December 29, 2025

CONTRACT NO. 1797

OHIO RIVER TUNNEL

ADDENDUM No. 11

File: O14-ST-606.dwg O14-ST-606 SMRT-014-RG SUPPORT OF EXCAVATION 07/30/2025 Sheet:

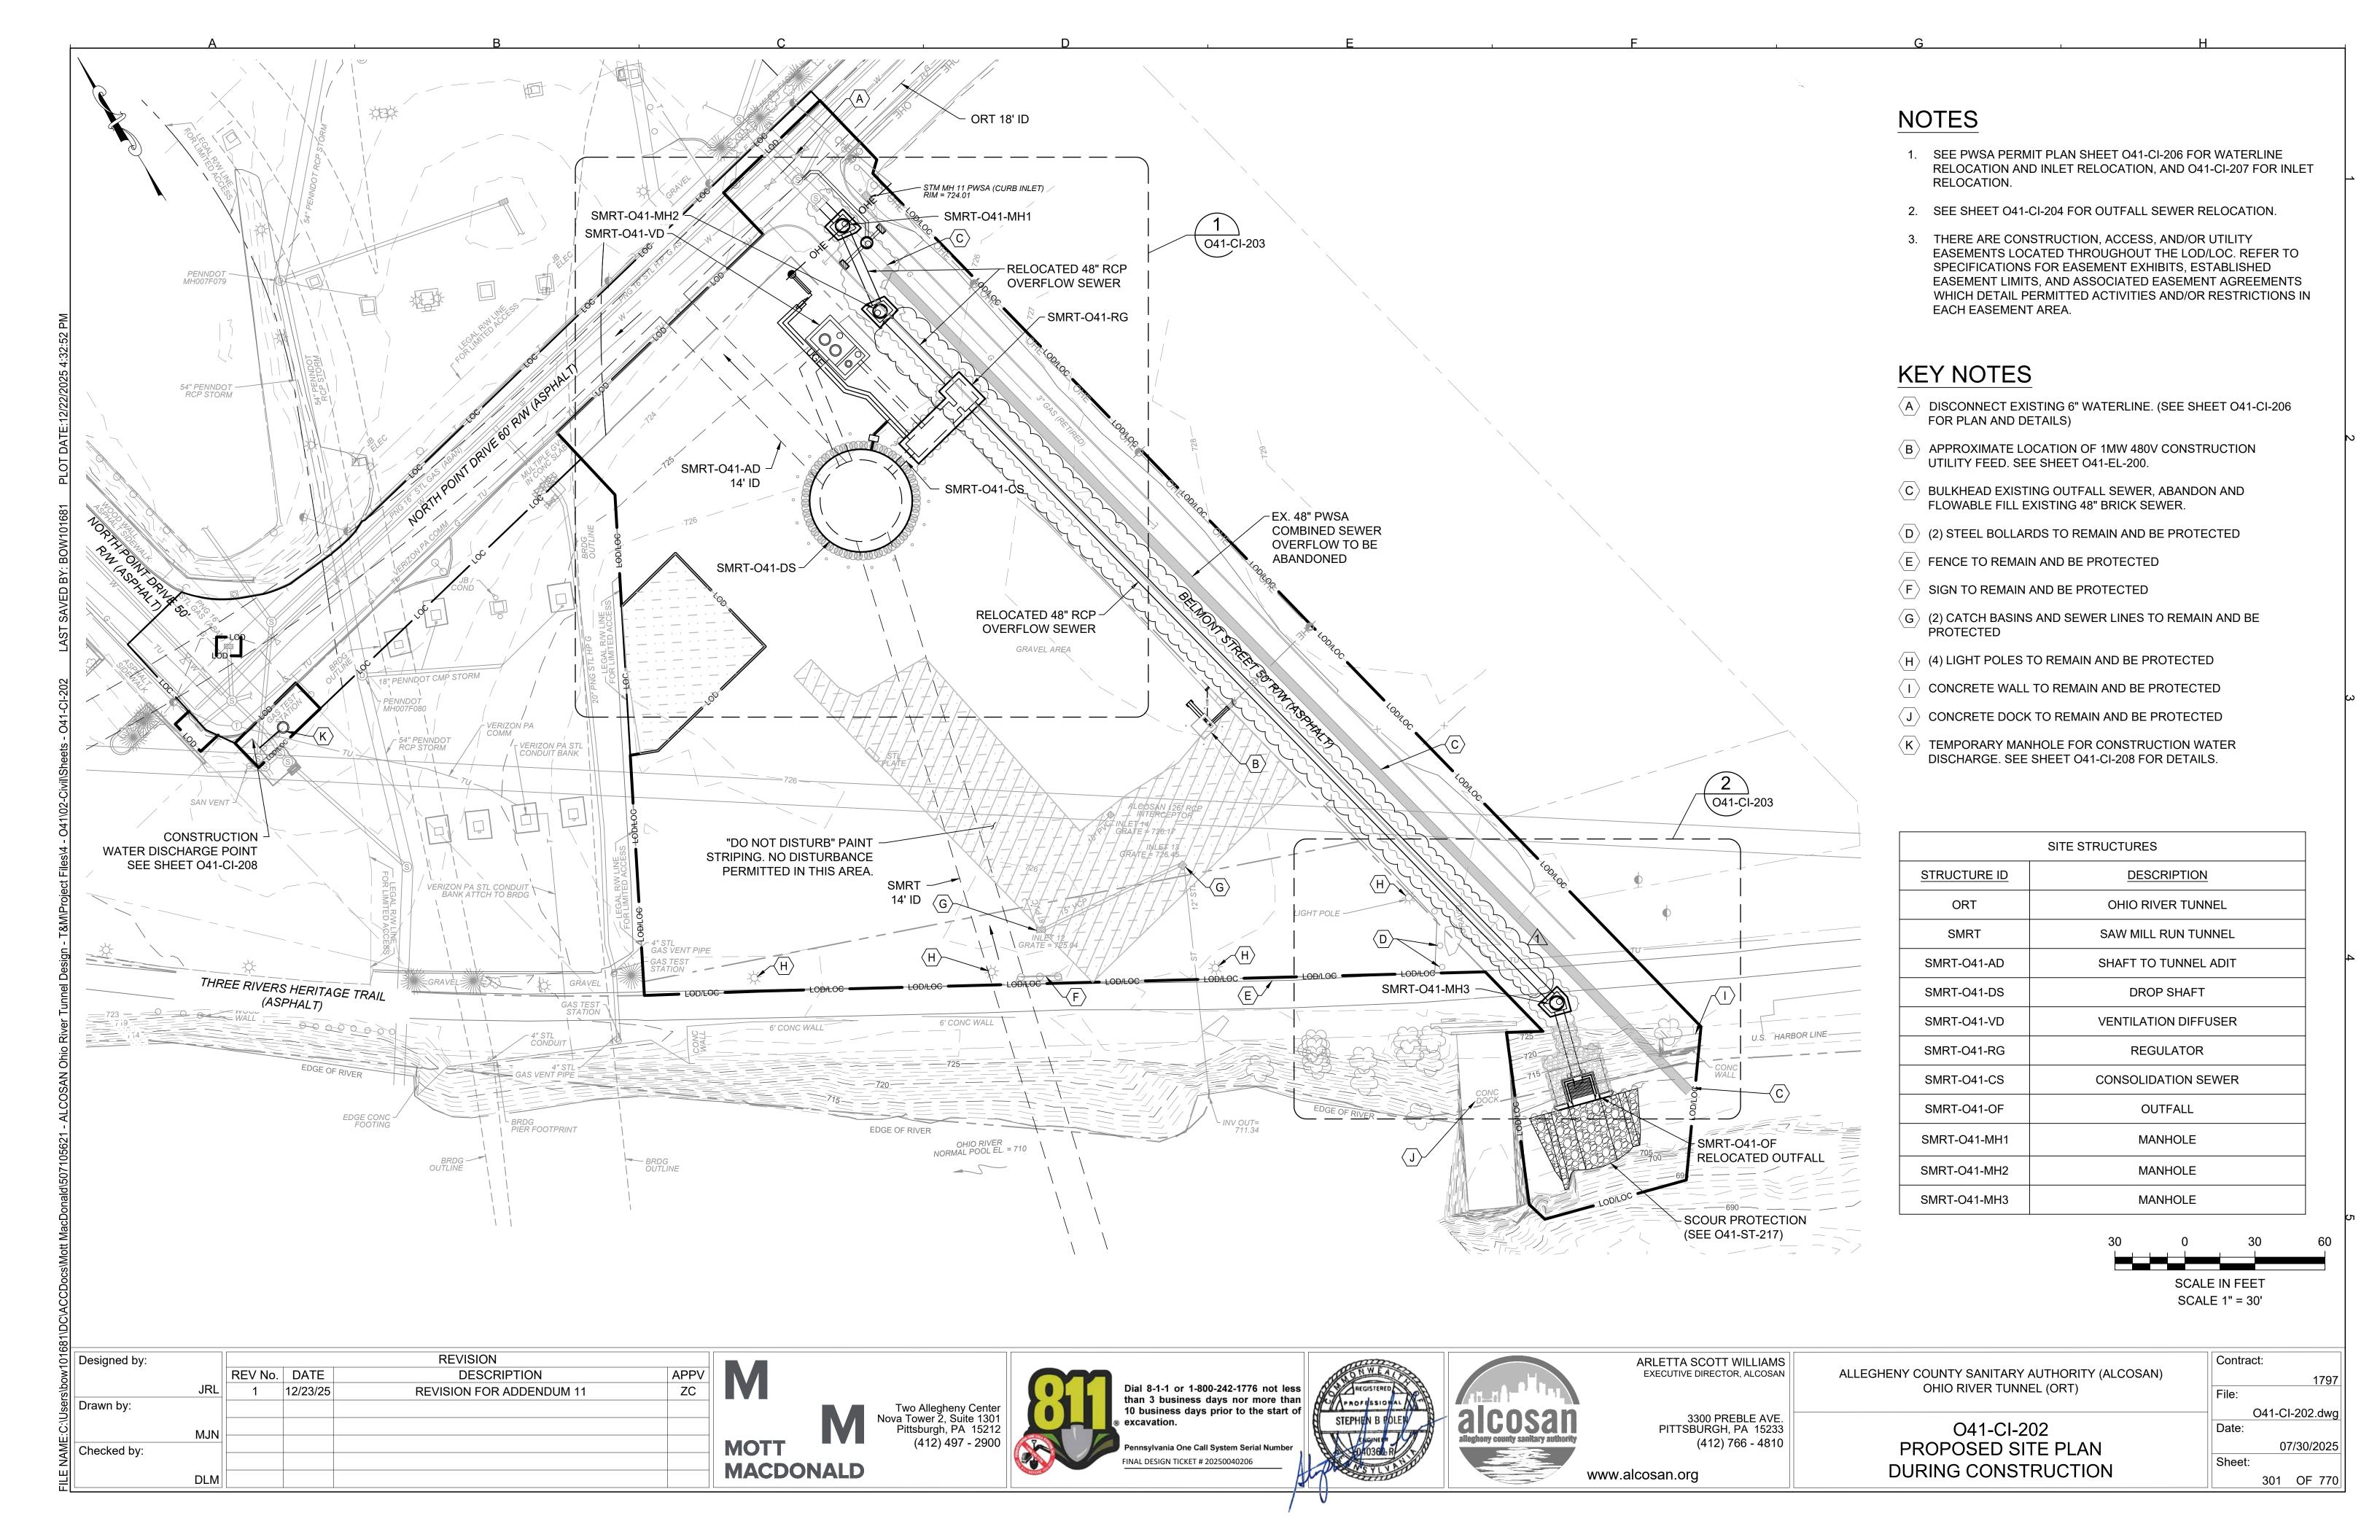
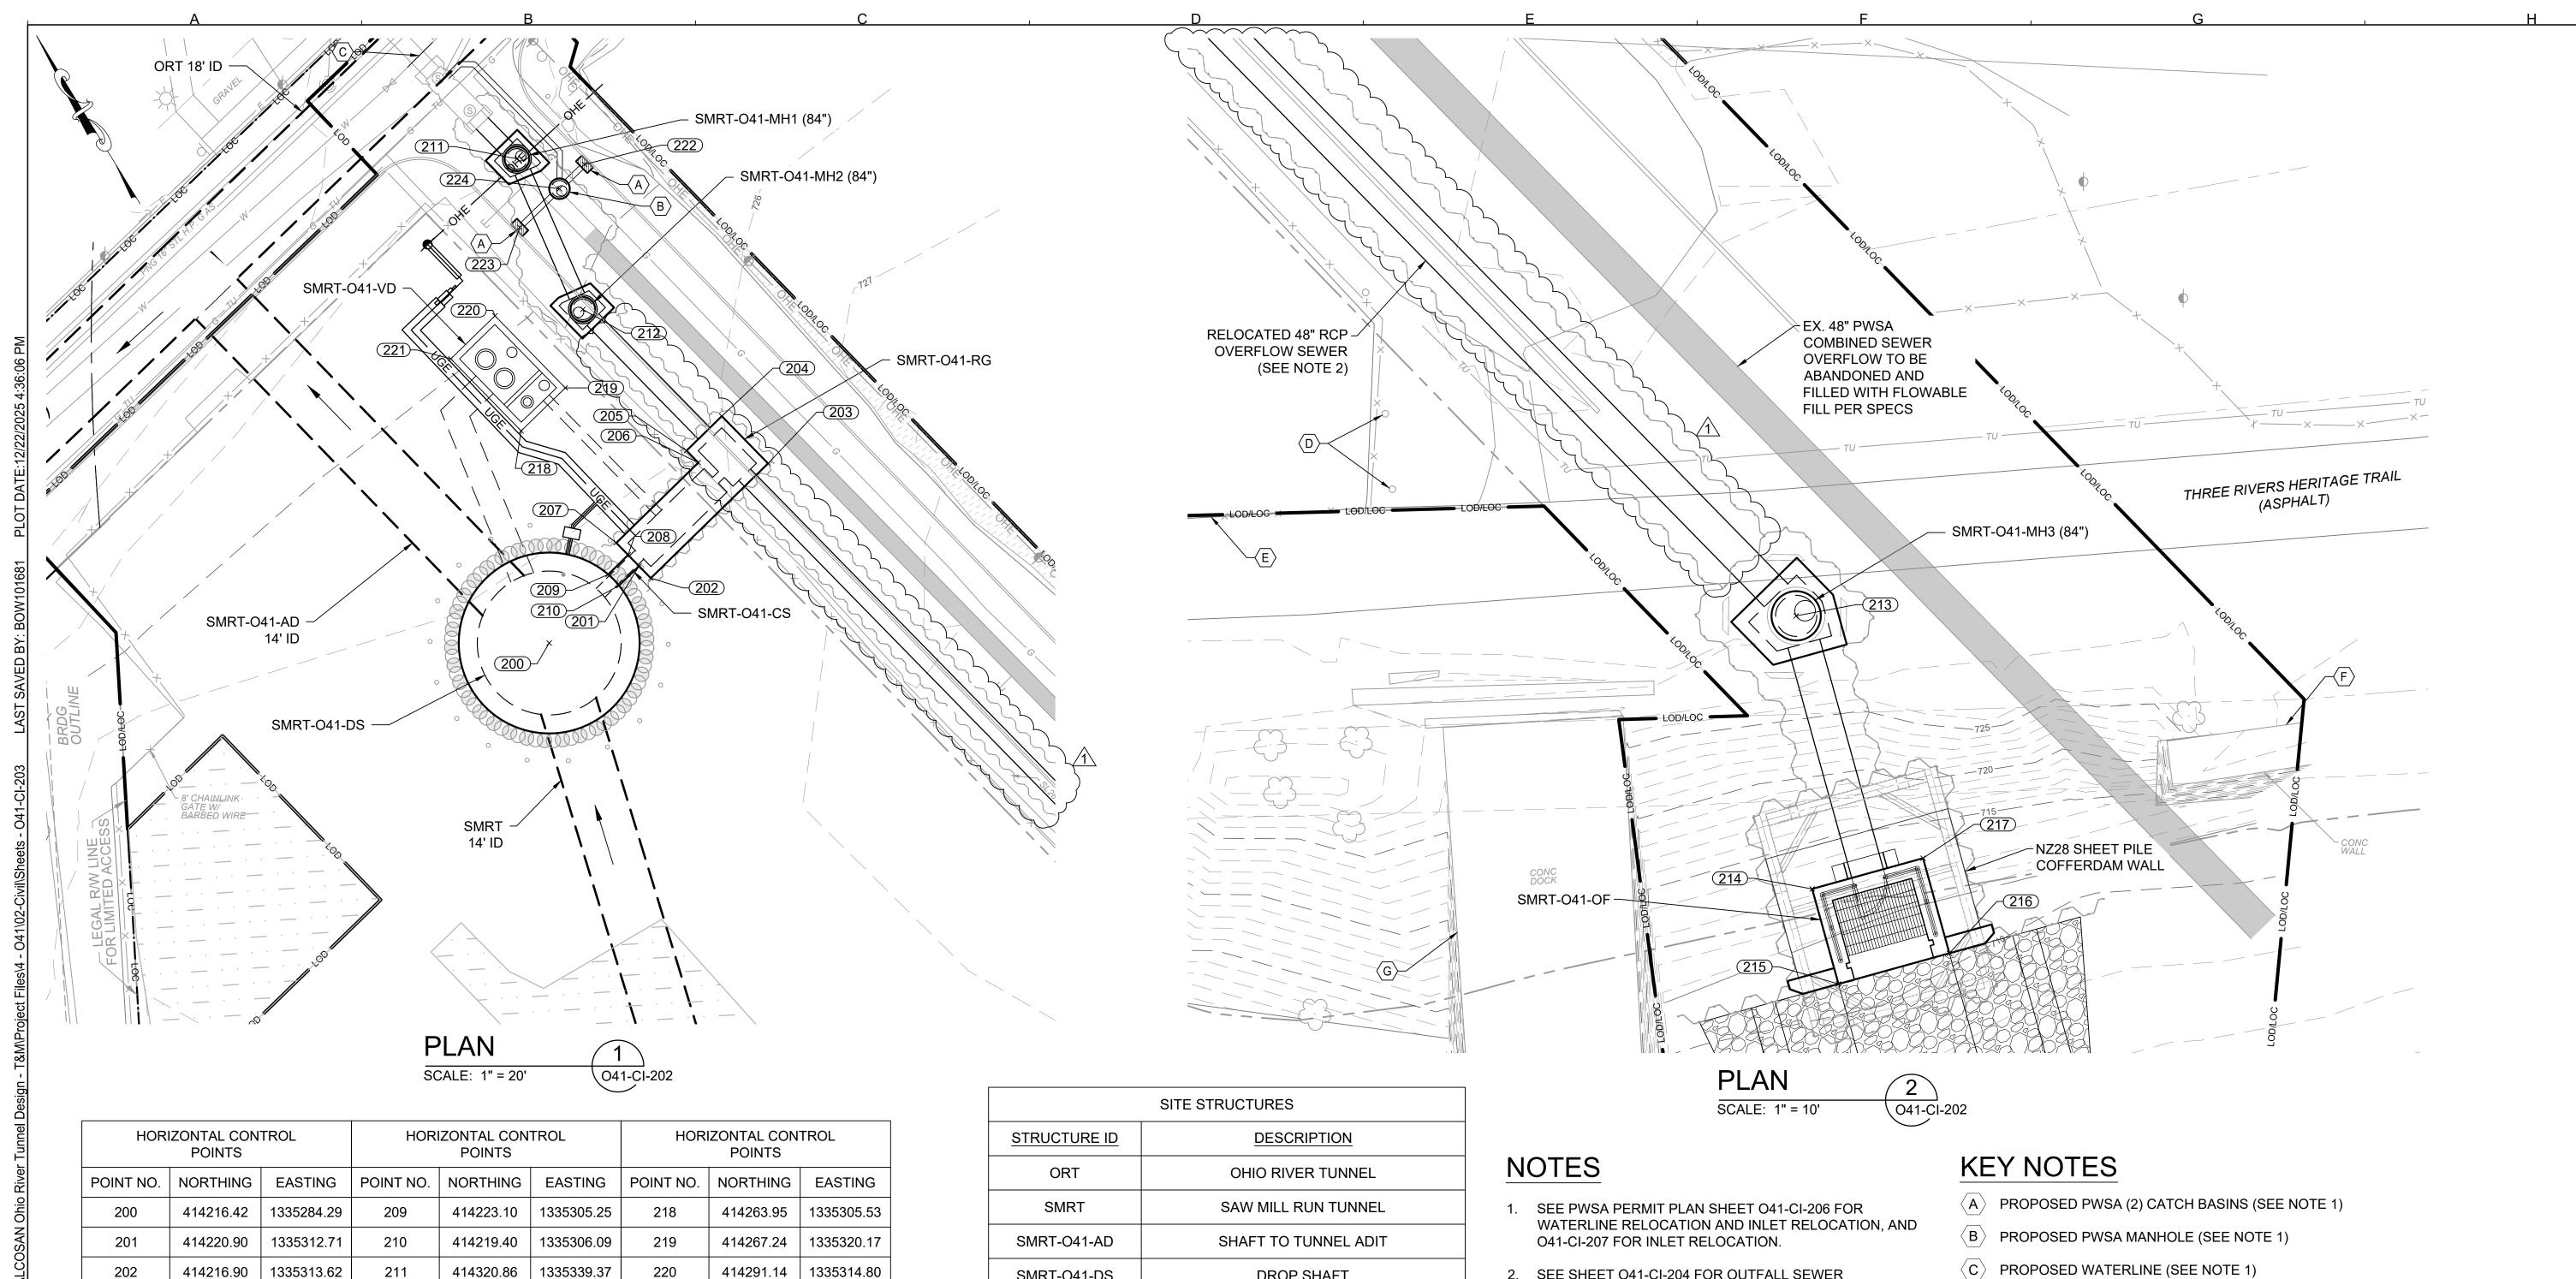
- Q7 Note 17 on Drawing O14-ST-606 states that "THE CONTRACTOR SHALL DISCHARGE ALL CONSTRUCTION WATER ARISING FROM THE 014-DS SITE TO THE EXISTING 014 REGULATOR (VORTEX DROP STRUCTURE) VIA THE PROPOSED 48" RCP WEST PIPE TRANSITION BOX." Additionally, Note II.G on Drawing 014-ST-607 requires that, prior to SOE installations, the Contractor must have completed "PREPARATION OF BYPASS PUMPING SYSTEM BETWEEN EXISTING MANHOLE NUMBER MN-01 ON THE 42" RCP AND NEWLY INSTALLED FLOW TRANSITION BOX TO THE 014 REGULATOR." This Transition Box, as identified by Suggested Construction Sequence #9 on Drawings 014-ST-604 and 014-ST-608, is located inside the Secant Pile SOE for the new Regulator. As there is significant discharge construction water associated with secant pile construction and other construction activities that are shown to occur before Suggested Construction Sequence #9, making this sequencing and requirements appear to be in direct conflict. Is there not an alternate route for discharging construction water to the existing Regulator?

Note 17 on Sheet O14-ST-606 has been revised to: THE CONTRACTOR SHALL DISCHARGE ALL CONSTRUCTION WATER ARISING FROM THE O14-DS SITE TO THE EXISTING O14 REGULATOR (VORTEX DROP STRUCTURE) VIA THE PROPOSED 48-INCH RCP WEST PIPE TRANSITION BOX.
